Final Set, Jefferson Village Phase II  
(Bulletin 6)

JEFFERSON VILLAGE

TYPICAL PAVEMENT CROSS SECTIONS

HOR. SCALE: NO SCALE  
VER. SCALE: NO SCALE  
DATE: 3-27-00  
JOB NO.: DE99011  
FILE NO.: DE9911X1  
SHEET NO.: P-0.2

PROPOSED TYPICAL CROSS SECTION  
FOR ST. CLAIR AVE.  
NOT TO SCALE

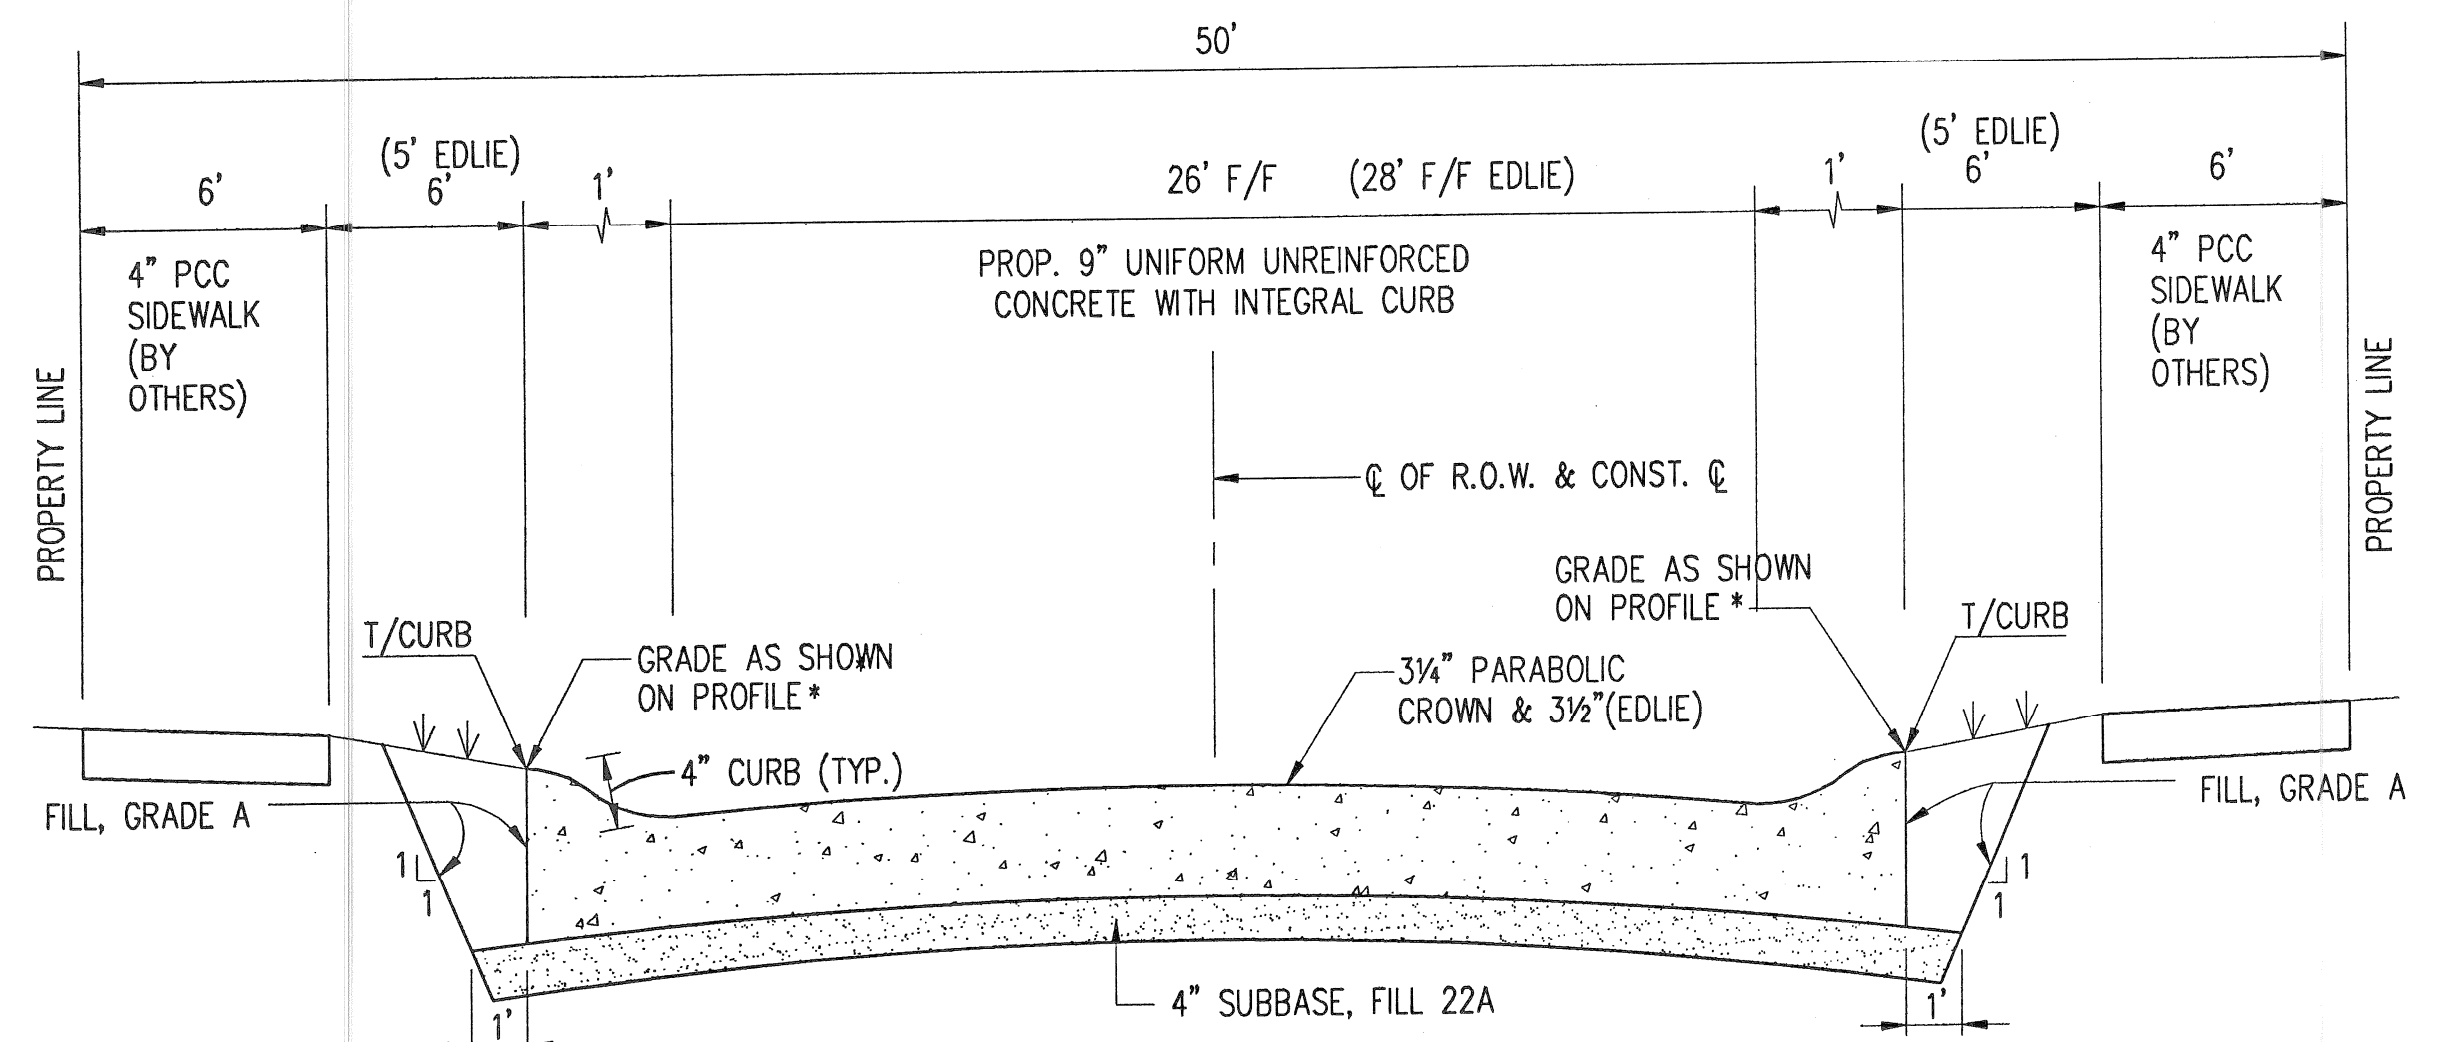
\* THE TYPE OF CURB WAS CHANGED FROM 7" HIGH STRAIGHT  
FACE TO 4" HIGH ROLLED CURB AFTER THE PREPARATION  
OF THE PAVING PLANS AND PROFILES (EXCEPTING FOR FREUD, MARQUETTE  
AND NEW STREET BETWEEN BENITEAU AND ST. JEAN). THE PAVEMENT  
ELEVATIONS AS SHOWN ON THE INTERSECTION DETAILS SHEETS SHALL BE  
MAINTAINED. ONLY THE TOP OF CURB ELEVATIONS SHALL BE DROPPED BY  
0.25' (3"). THIS SHALL BE ACHIEVED BY SUBTRACTING 0.25' (3") FROM THE  
TOP OF CURB ELEVATIONS SHOWN ON THE PROFILES.

TYPICAL PAVEMENT CROSS SECTIONS

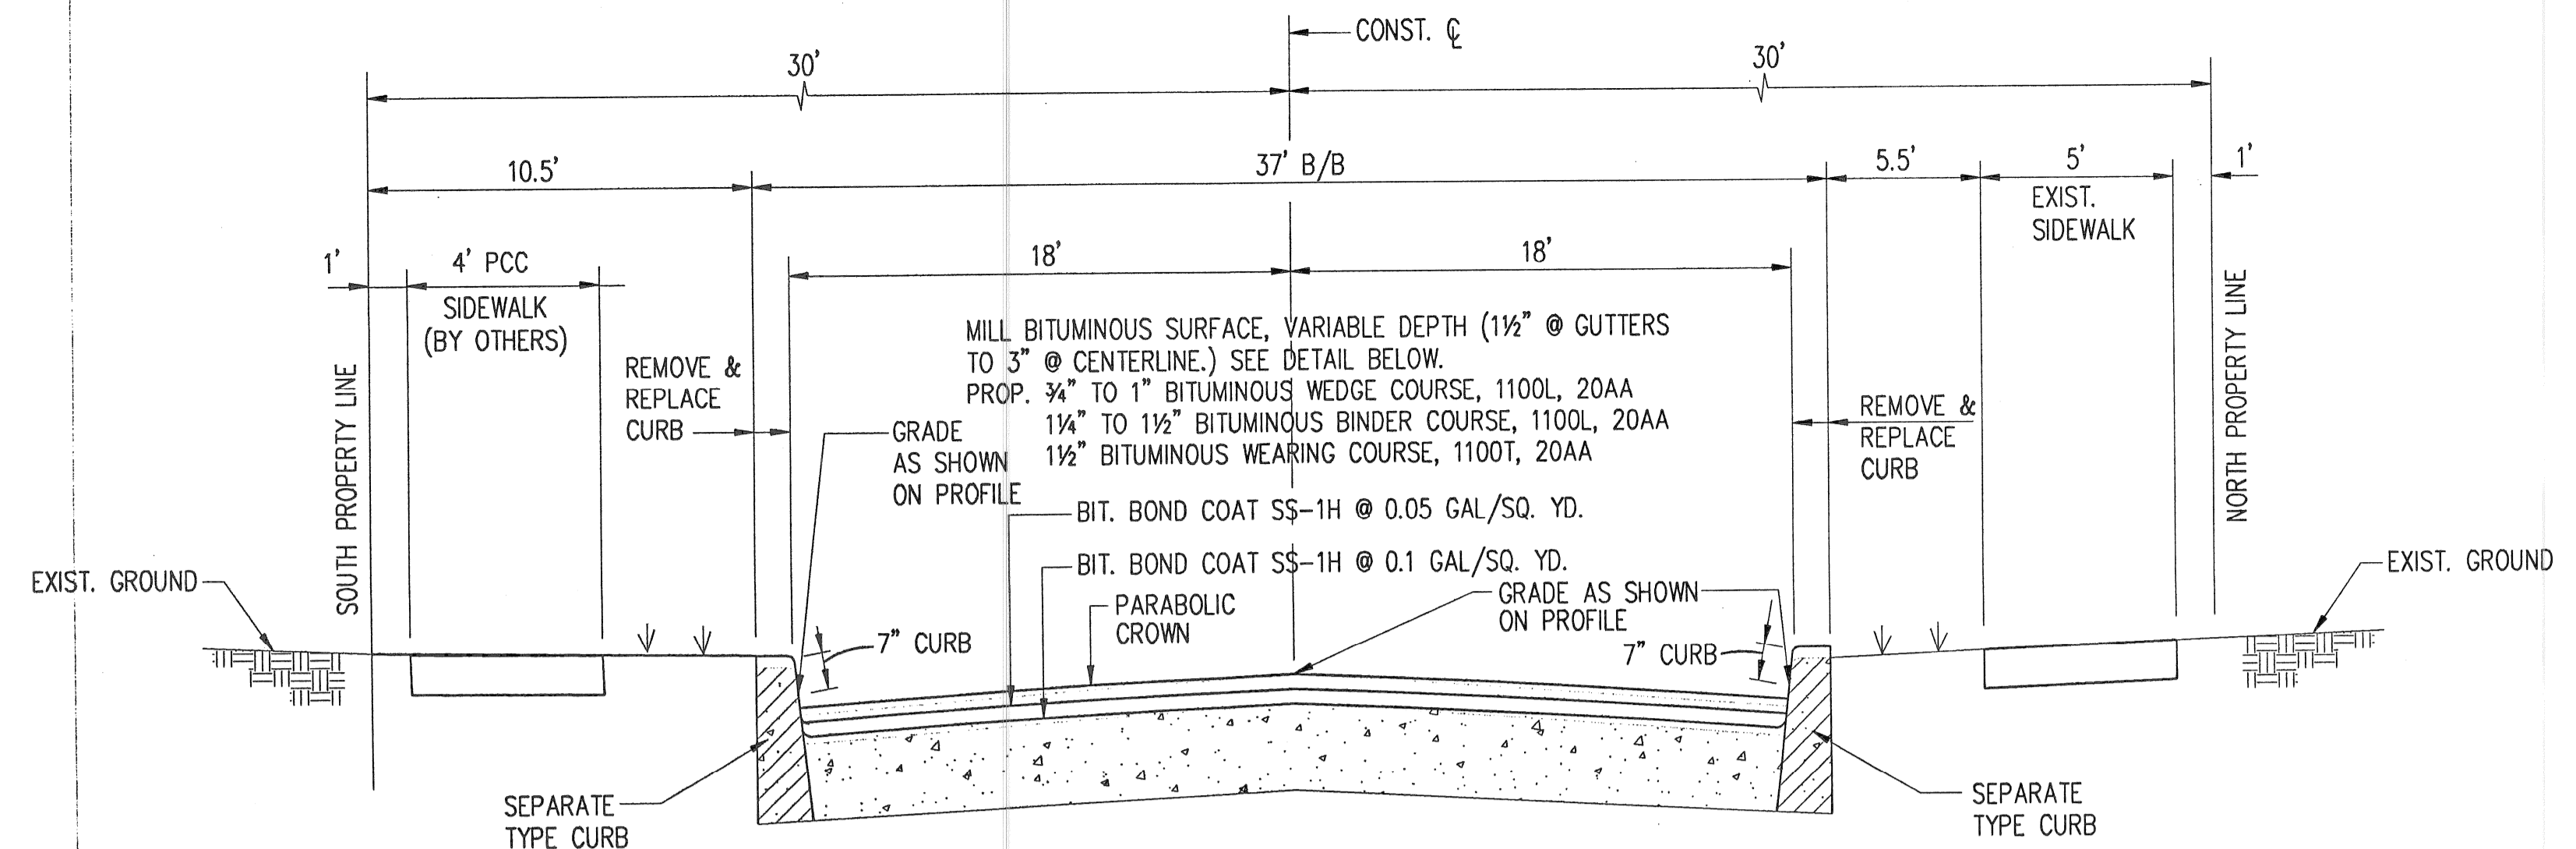
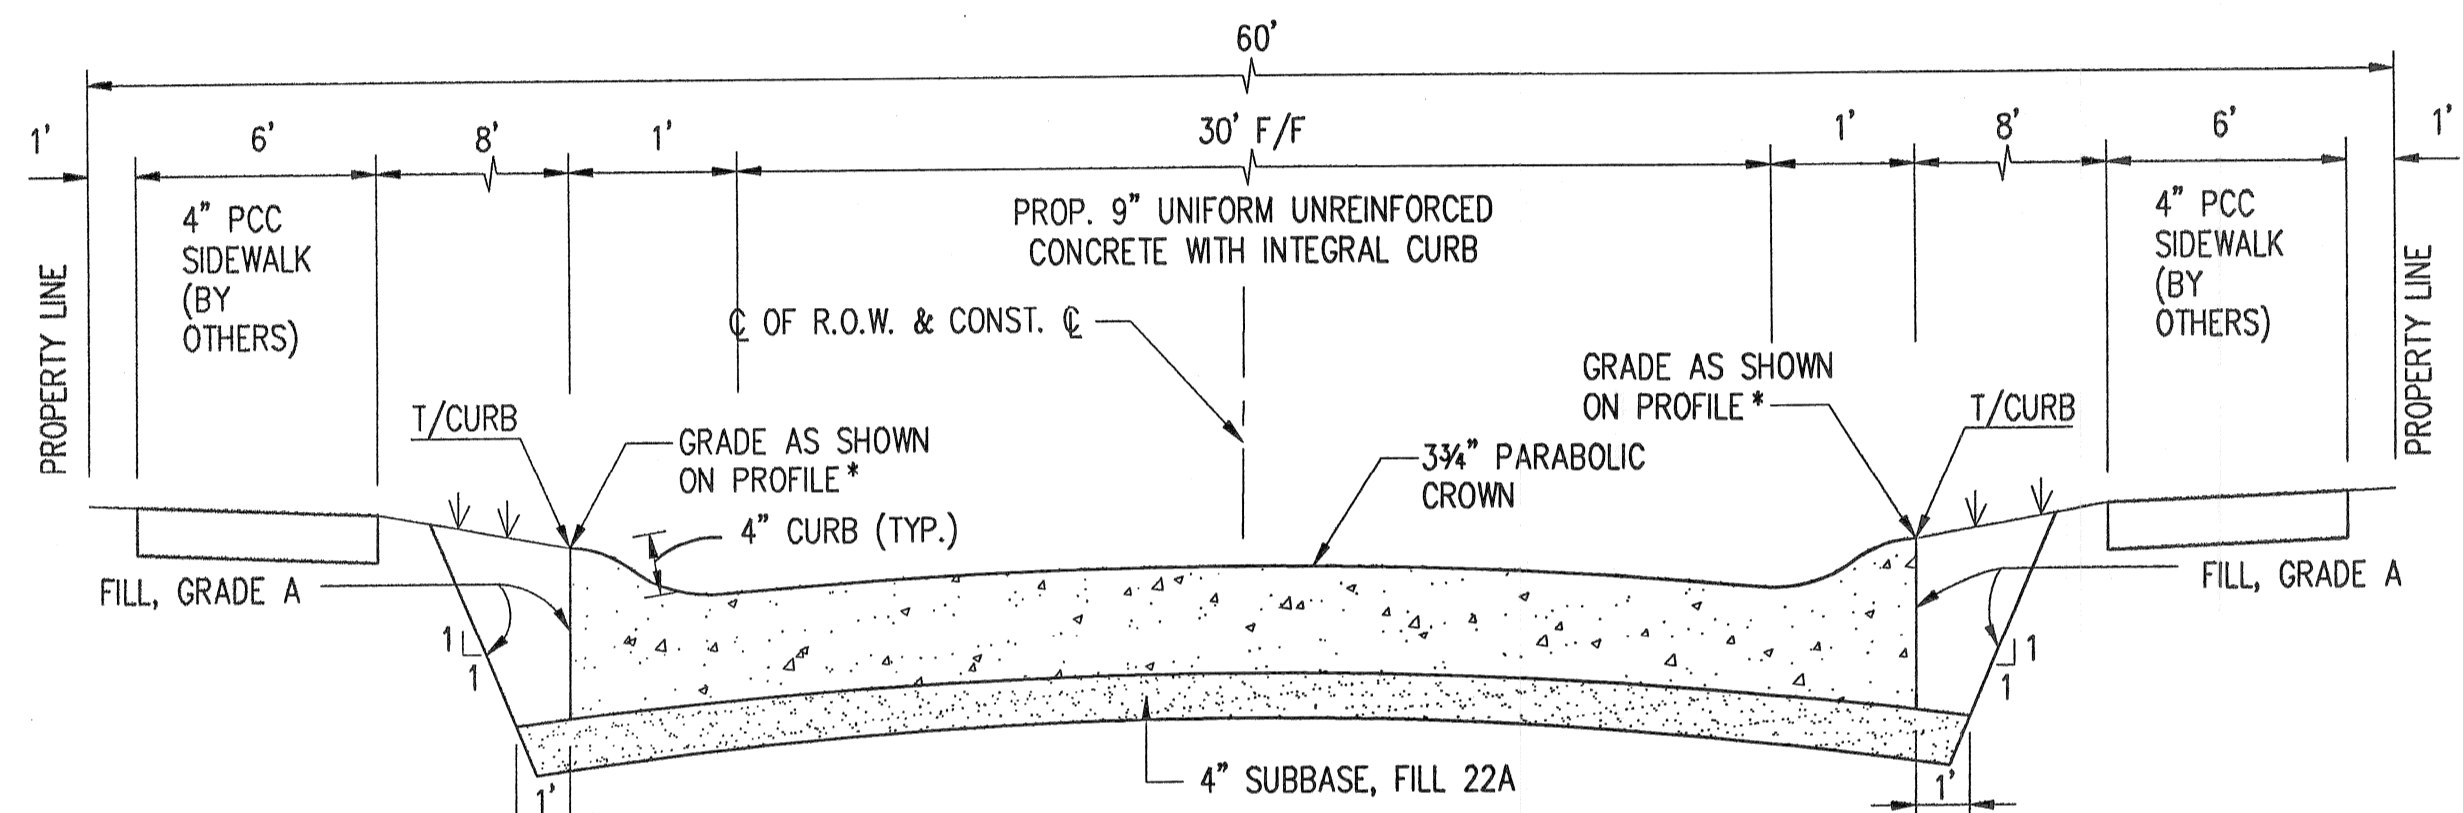
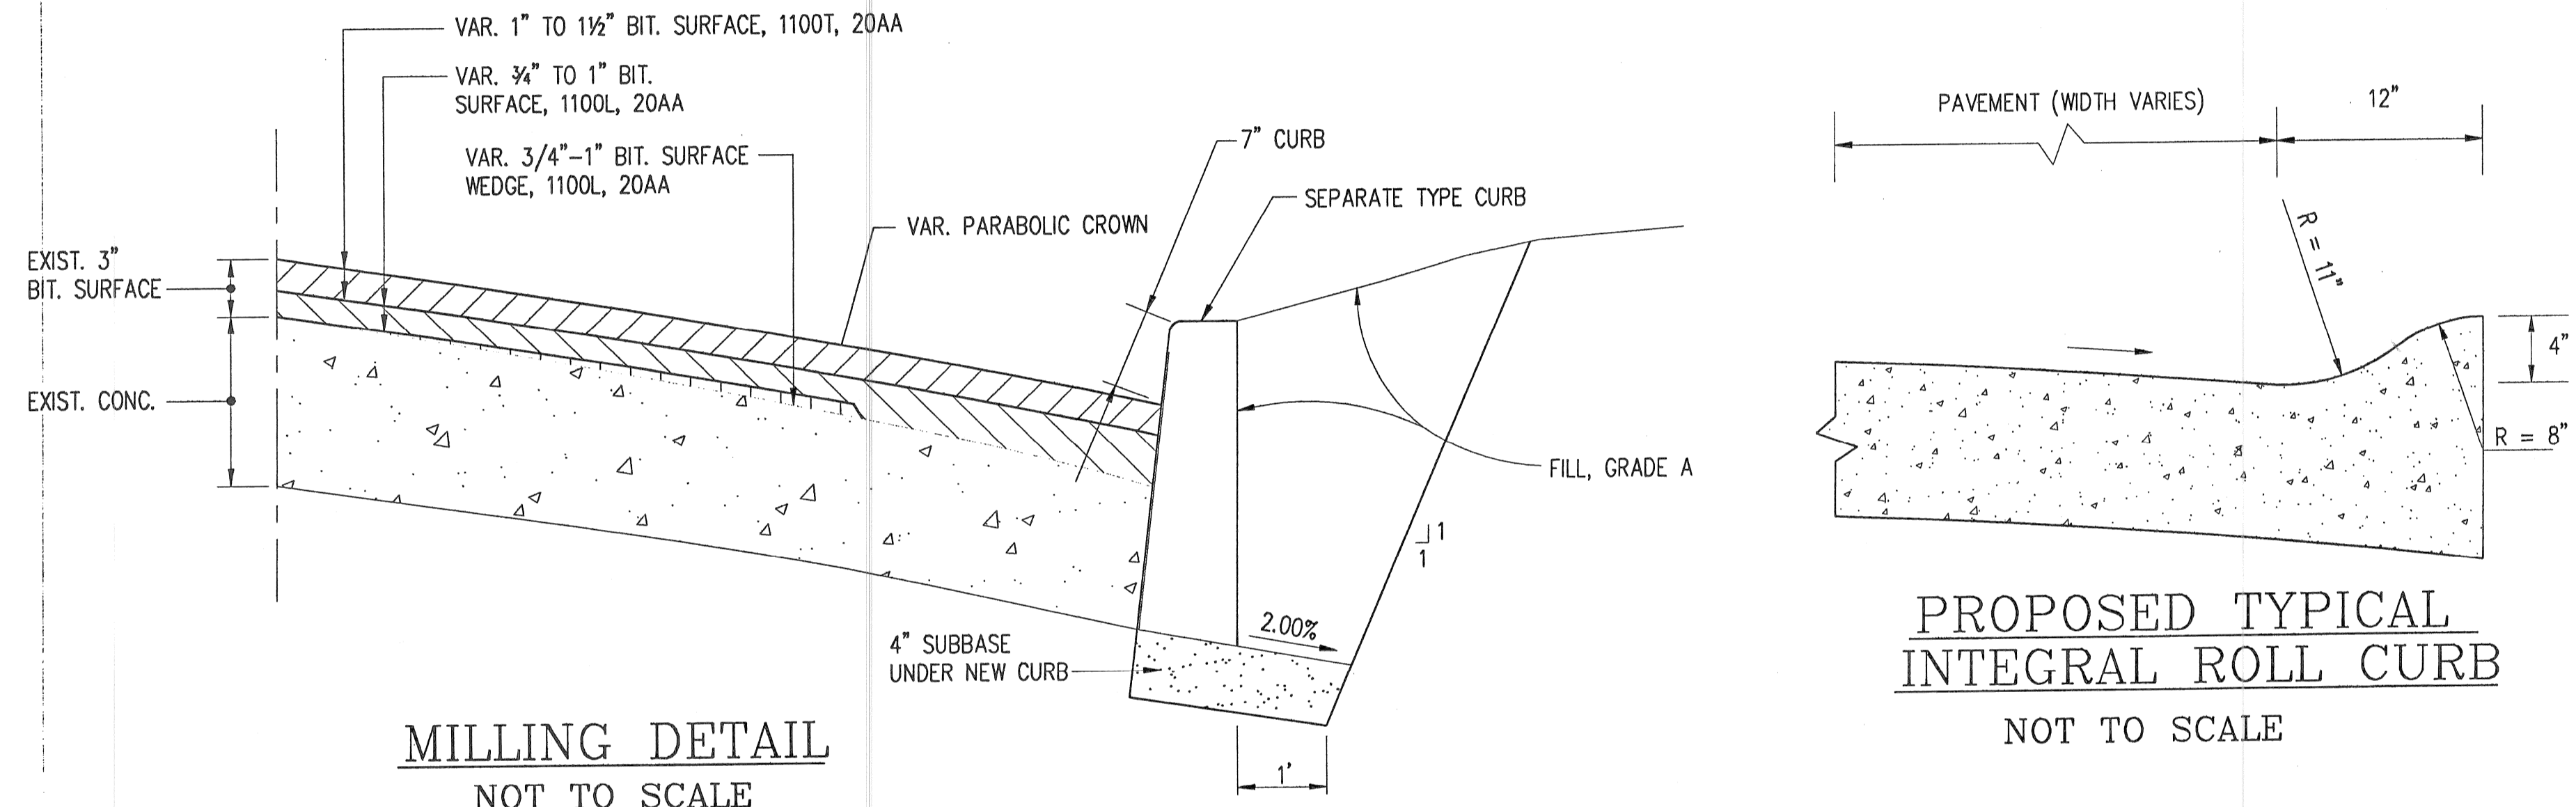
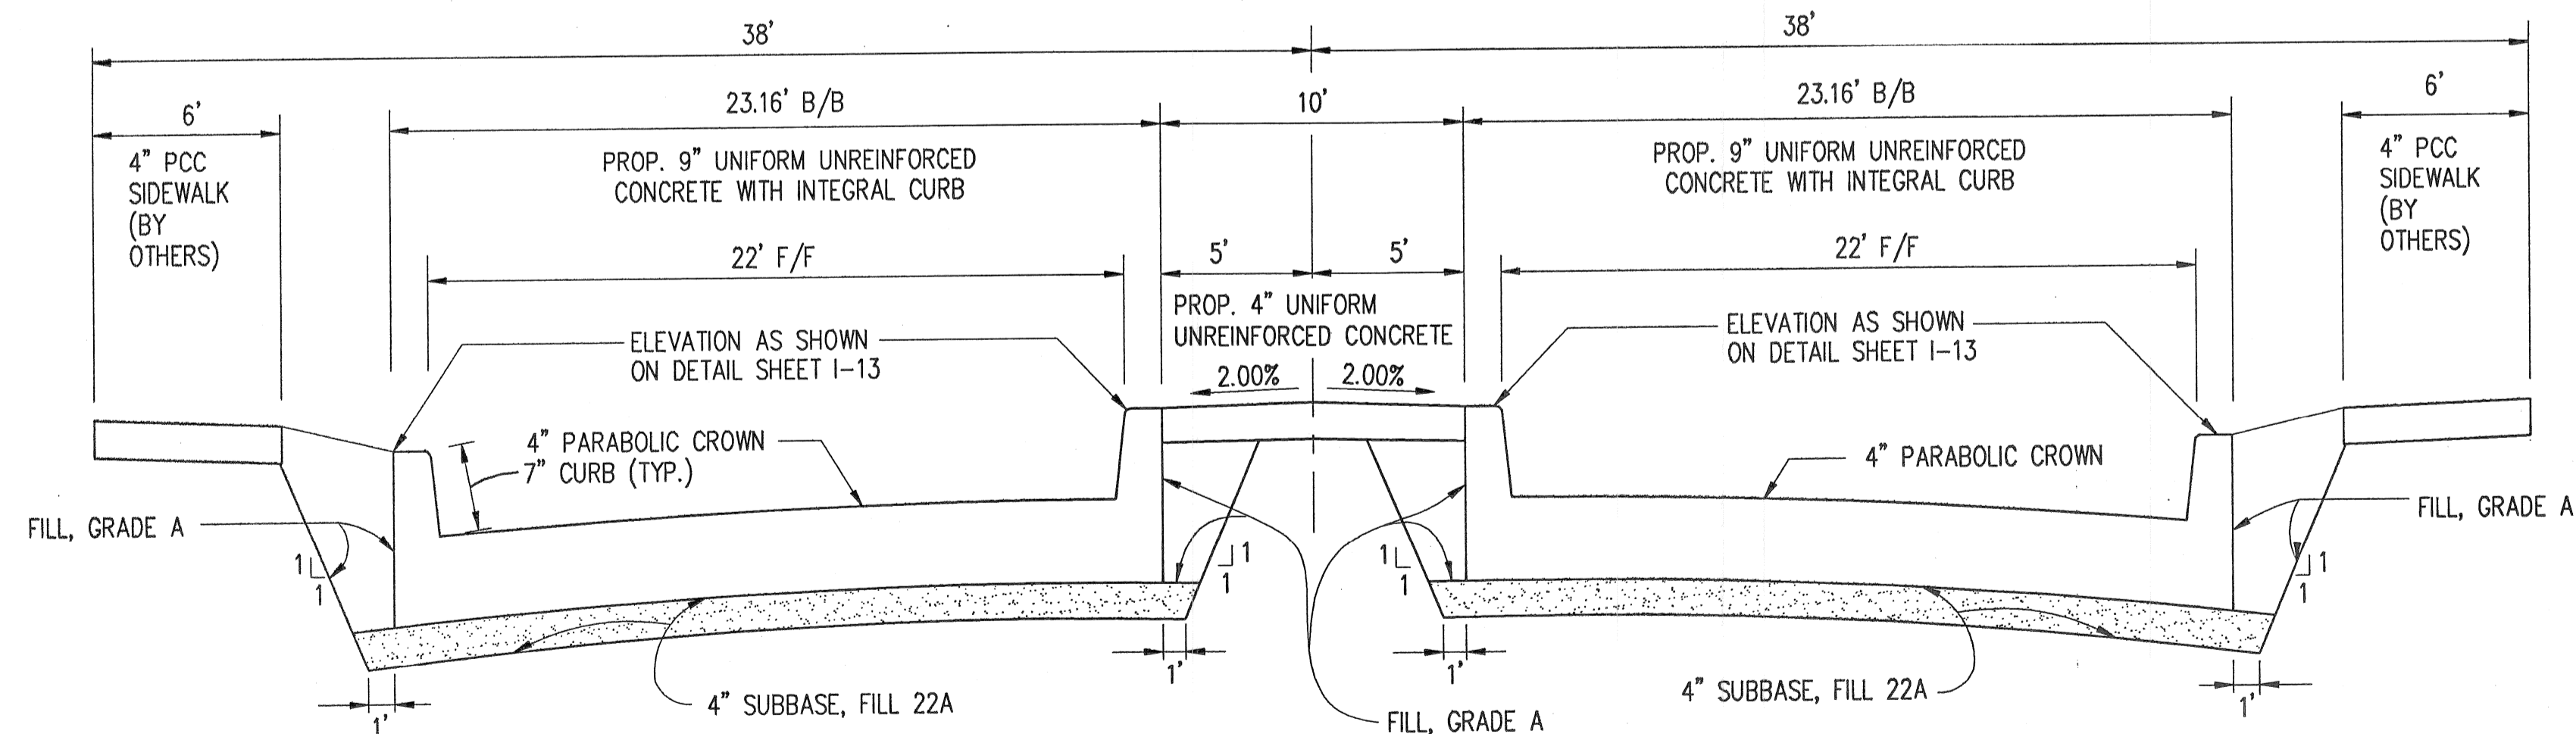
**NOTES:**  
FOR EXPANSION & CONTRACTION JOINT SPACING,  
SEE CITY OF DETROIT STANDARD C-4379  
\* THE TYPE OF CURB WAS CHANGED FROM 7" HIGH STRAIGHT  
FACE TO 4" HIGH ROLLED CURB AFTER THE PREPARATION  
OF THE PAVING PLANS AND PROFILES (EXCEPT FOR FREUD, MARQUETTE  
AND NEW STREET BETWEEN BENITEAU AND ST. JEAN). THE PAVEMENT  
ELEVATIONS AS SHOWN ON THE INTERSECTION DETAILS SHEETS SHALL BE  
MAINTAINED. ONLY THE TOP OF CURB ELEVATIONS SHALL BE DROPPED BY  
0.25' (3"). THIS SHALL BE ACHIEVED BY SUBTRACTING 0.25' (3") FROM THE  
TOP OF CURB ELEVATIONS SHOWN ON THE PROFILES.
